DEVELOPMENT APPLICATION ASSESSMENT REPORT

Application Number:	DA2024/1031		
	•		
Responsible Officer:	Jordan Howard		
Land to be developed (Address):	Lot 26 DP 10571, 14 Bellevue Parade NORTH CURL CU NSW 2099		
Proposed Development:	Demolition works and construction of a dwelling house including a swimming pool		
Zoning:	Warringah LEP2011 - Land zoned R2 Low Density Residential		
Development Permissible:	Yes		
Existing Use Rights:	No		
Consent Authority:	Northern Beaches Council		
Land and Environment Court Action:	n: No		
Applicant:	Watershed Architects		
Application Lodged:	09/08/2024		
Integrated Development:	No		
Designated Development:	No		
State Reporting Category:	Residential - Single new detached dwelling		
Notified:	27/08/2024 to 10/09/2024		
Advertised:	Not Advertised		
Submissions Received:	1		
Clause 4.6 Variation:	Nil		
Recommendation:	Approval		
Estimated Cost of Works:	\$ 1,688,785.62

Figure 1 - Extract from Eastern Elevation with side boundary envelope encroachment in red.

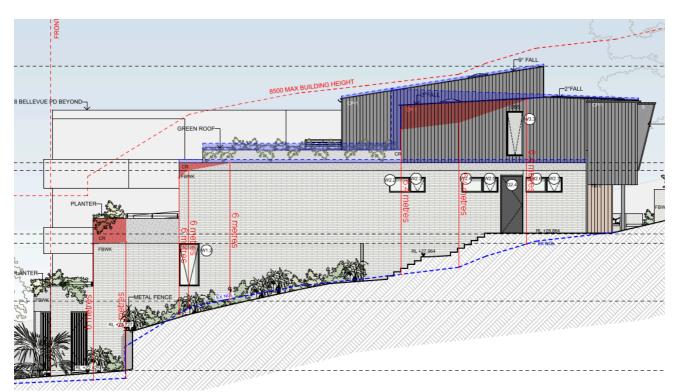
The proposed development encroaches the side building envelope on the eastern elevation as depicted in *Figure 1*. The proposed development also encroaches the building envelope on the western elevation as depicted in *Figure 2*.

Notably, building envelope non-compliance was one issue raised with the Applicant in a Request for Further Information letter. Amended plans were received in response, which reduced the size and scope of the proposed envelope breaches to the level currently proposed, depicted in the above figures.

The proposed development is compliant with the maximum height of buildings development standard and side setback built form controls. The design also incudes tapering in of setbacks at upper levels and stepping of the dwelling across the site to accommodate for steeply sloping topography. The breaches are considered to be minor and to result from the sloped topography of the site, demonstrated by the isolation of breaches to the top downhill corners of each level. The development is not considered to be visually dominant by virtue of its height and bulk.

The proposed development is not considered to result in any unreasonable amenity impacts on adjoining properties (including light, solar or privacy impacts) and is considered to provide adequate spatial separation between buildings. Again, the breaches are considered to be

minor and to result from the sloped topography of the site, demonstrated by the isolation of breaches to the top downhill corners of each level.
